SITE PLAN  
1" = 40'

HOMWOOD SUITES by Hilton  
Goldsboro, NC

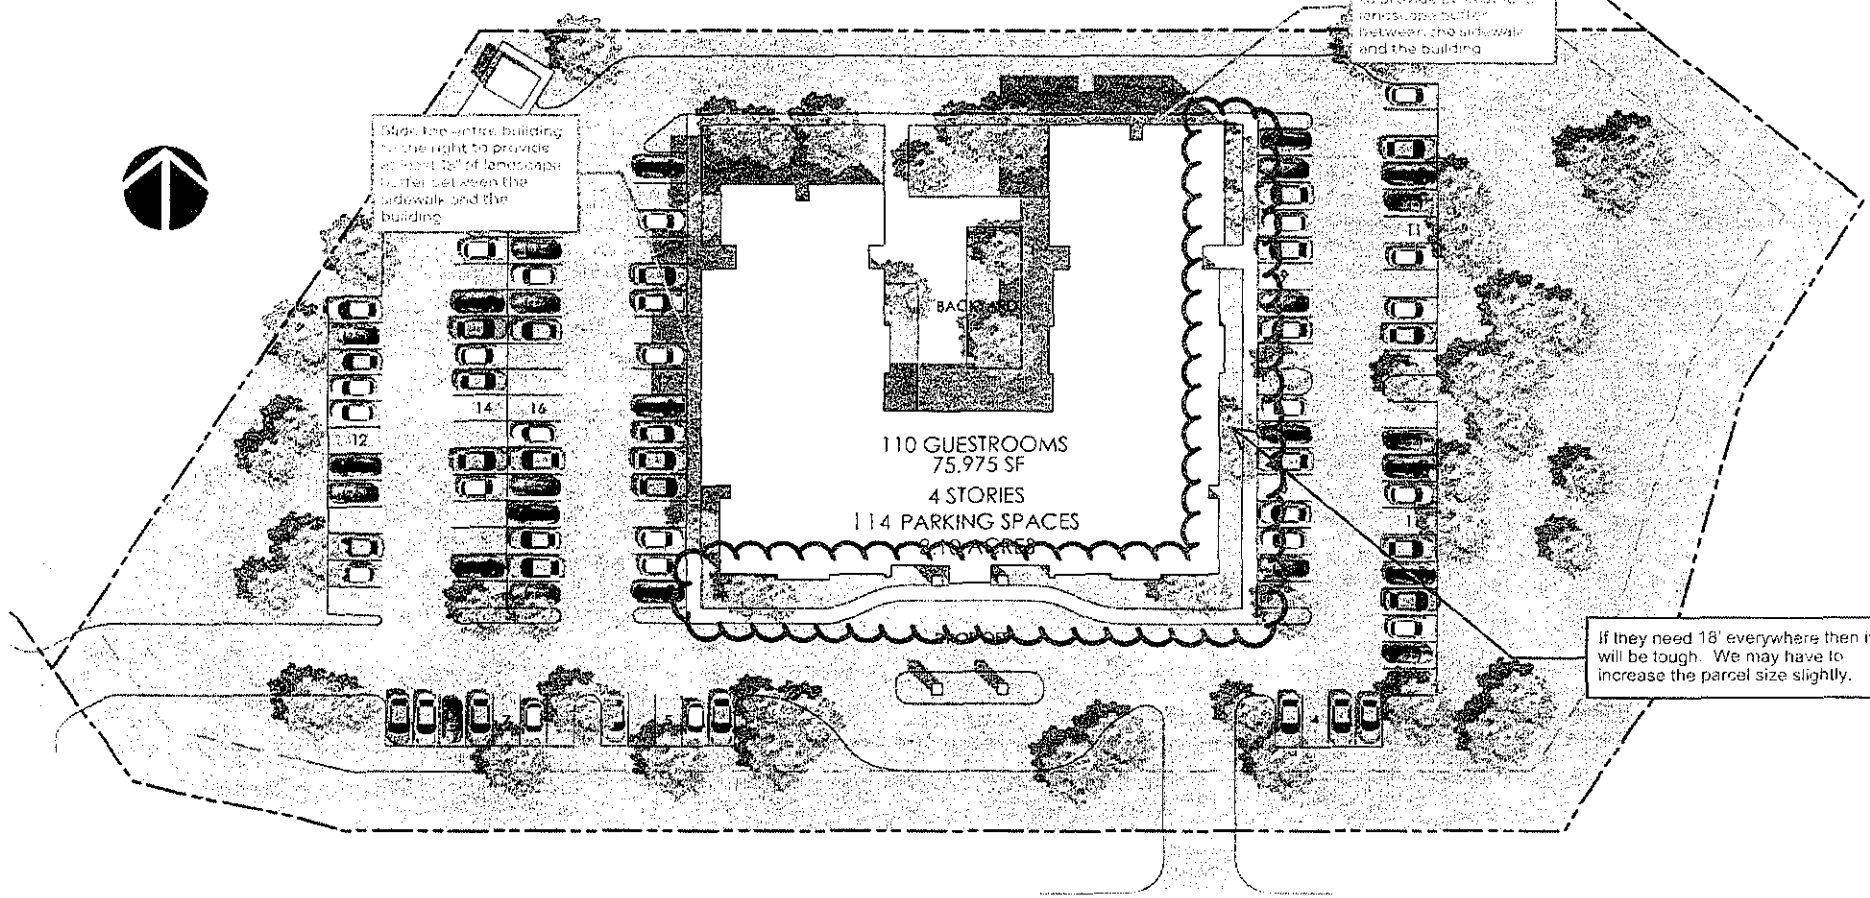
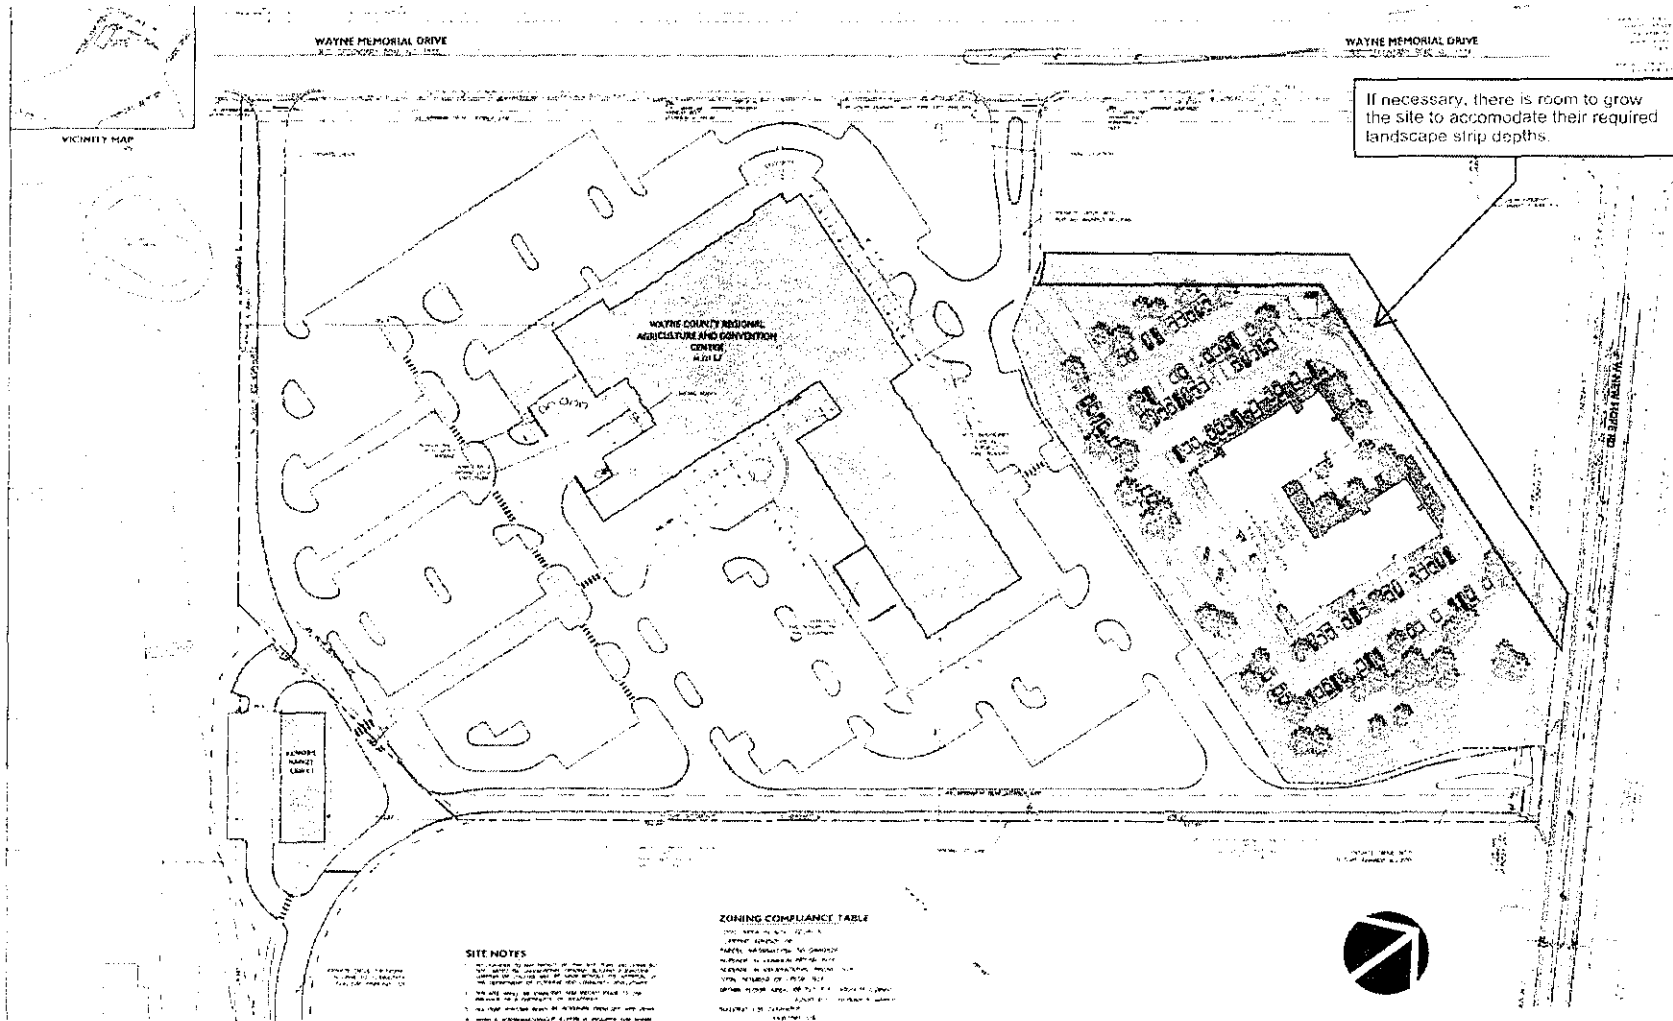
Slide the entire building to rise from the lot south to provide at least 18' of landscape buffer between the sidewalk and the building

Slide the entire building to the right to provide at least 18' of landscape buffer between the sidewalk and the building

I'm not sure how we achieve this. I think we'd need input from the civil to verify actual setbacks, buffers, etc. to know exactly how this impacts the need to increase the parcel size.

If they need 18' everywhere then it will be tough. We may have to increase the parcel size slightly.

If necessary, there is room to grow the site to accommodate their required landscape strip depths.

FI  
1" = 20'

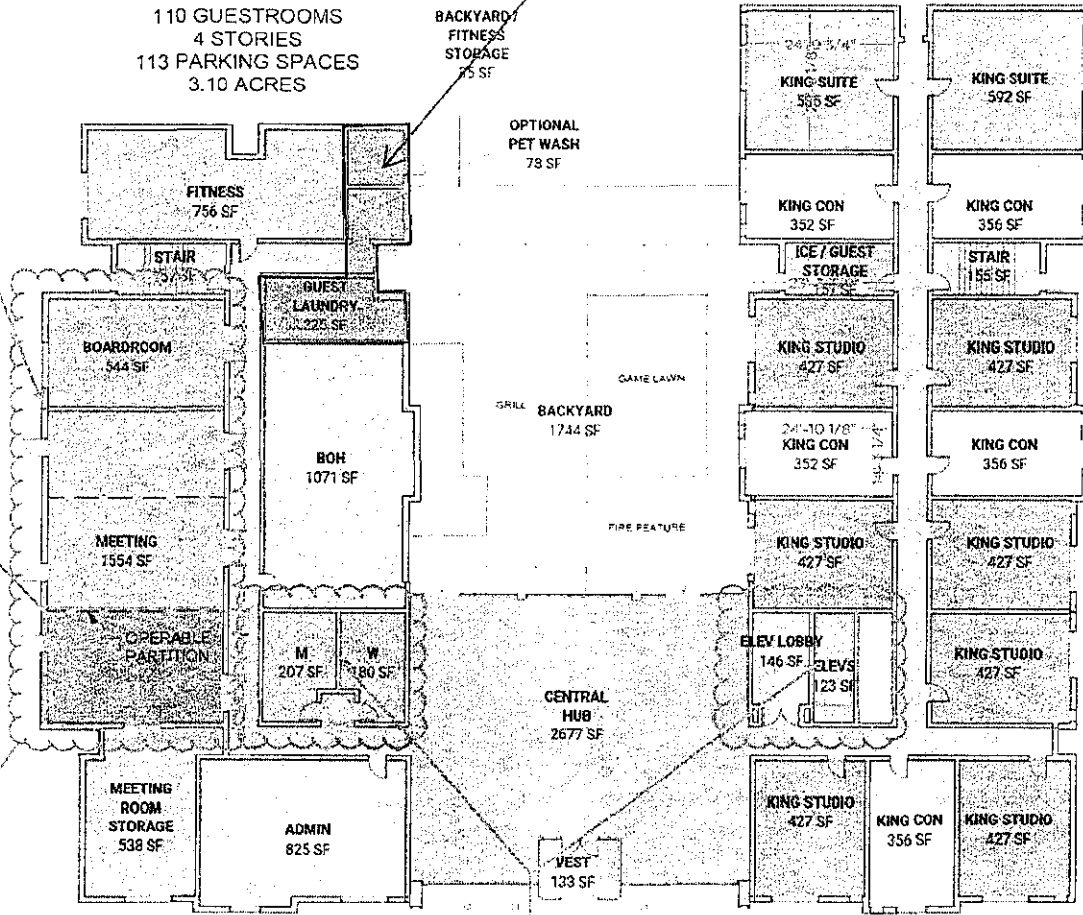
Split the entire building on the front (open north) to provide at least 10' of landscape buffer between the exterior and the building

Split the entire building on the right to provide at least 10' of landscape buffer between the exterior and the building

Meeting rooms are not shown and can be provided at the discretion of the client. The meeting room is a programmatic space that has been shown. This plan does not show where main electrical and mechanical spaces are planned for (found along this space on previous 100 prototypes). Location of elements, the layout, and the path to provide room for main MEP spaces.

Swap location of elevators/elev lobby with the public restrooms to ensure that restrooms terminates at main laundry

Connector must be connected to a studio or suite. Connecting a QQ Connector to a QQ Studio is not permitted. Change Studio next to stair to a King Studio.

We could reconfigure this area to try and avoid losing meeting space if necessary.

If you don't want to lose this meeting space, then we can shift things around and lose the pet wash station, maybe make fitness storage an outbuilding and shift guest laundry to one of the interior corners upstairs so that you don't lose any guestrooms.

This is a good programmatic proposal so that the linen chute is by the laundry. Our only logic in locating the restrooms where they were is so that they could serve the large crowds in the meeting area easily but the function of the laundry is more critical. This is a very easy change.

We could change this and find another place for a QQ Studio stack if that is an important room type.

We could shift guest laundry to this corner on one of the upper floors to avoid losing meeting space if that is important.

TYP. UPPER FLOOR PLAN | 1" = 20'

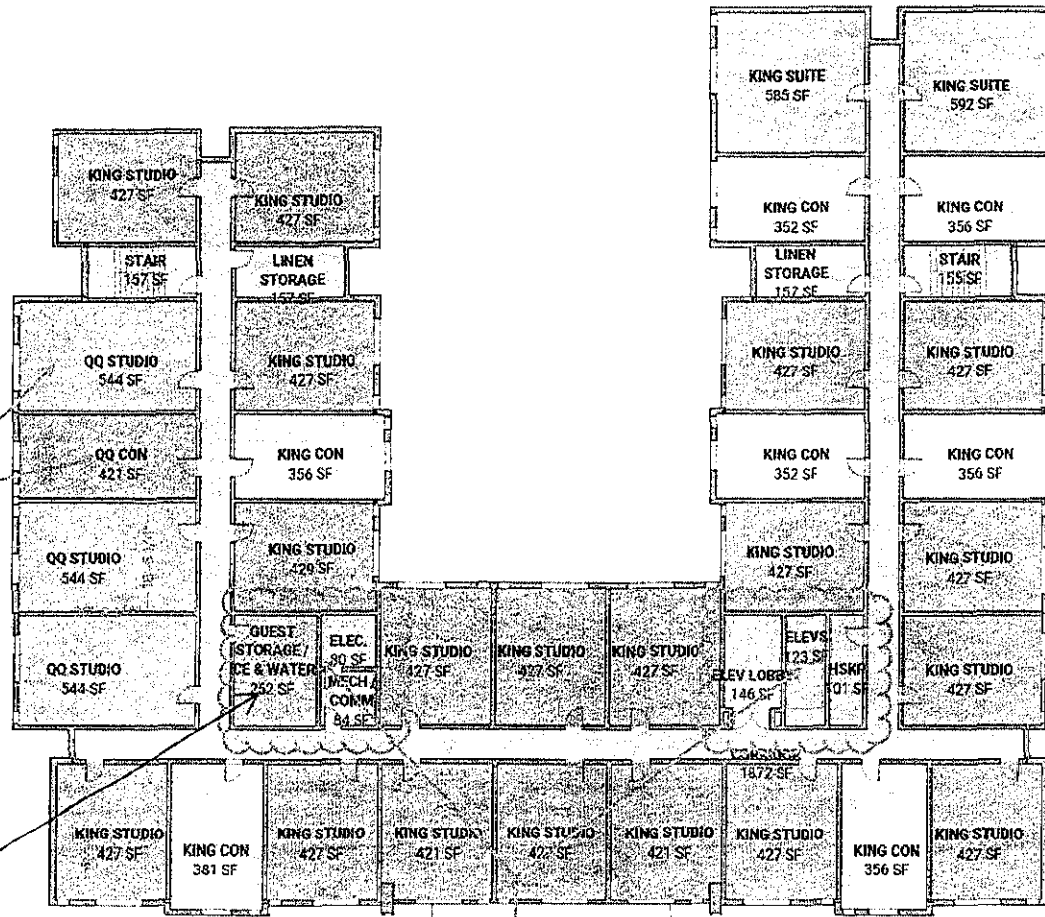
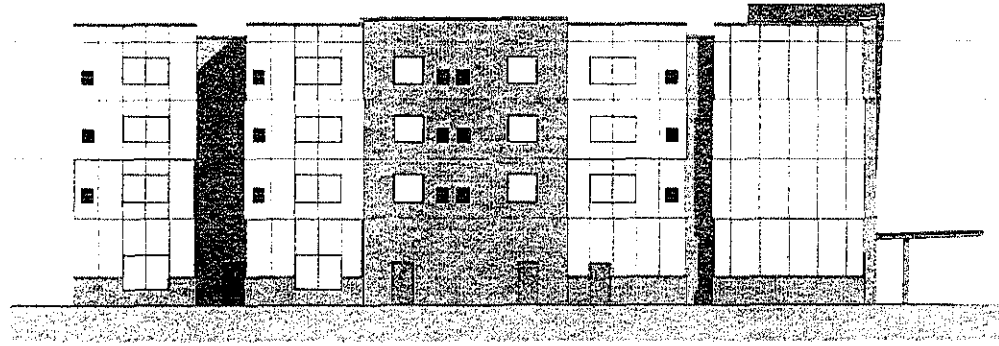
Swap location of elevator and lobby with guest storage, to ensure that when chute terminal is at main laundry.

See note on first floor. We can easily accommodate this change.

BUILDING ELEVATIONS  
1" = 20'

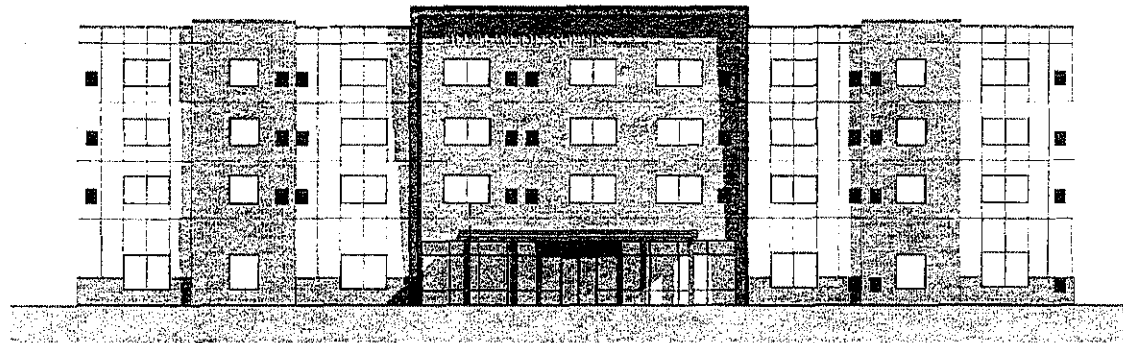
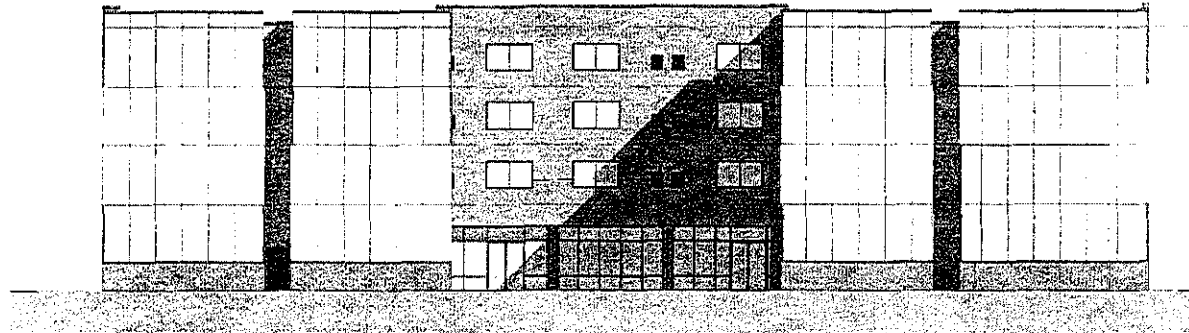
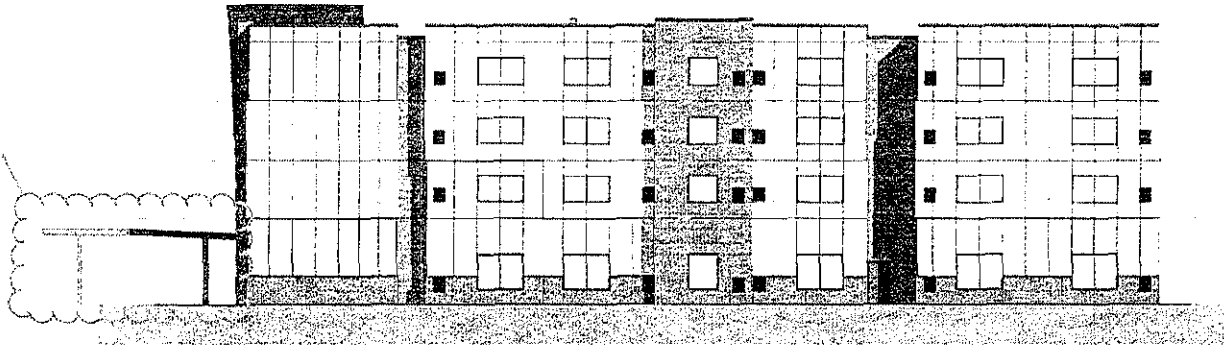
Can you do a 4 column design as a cantilevered porte cochere can become very expensive. Although we would work with you on your design preferences.
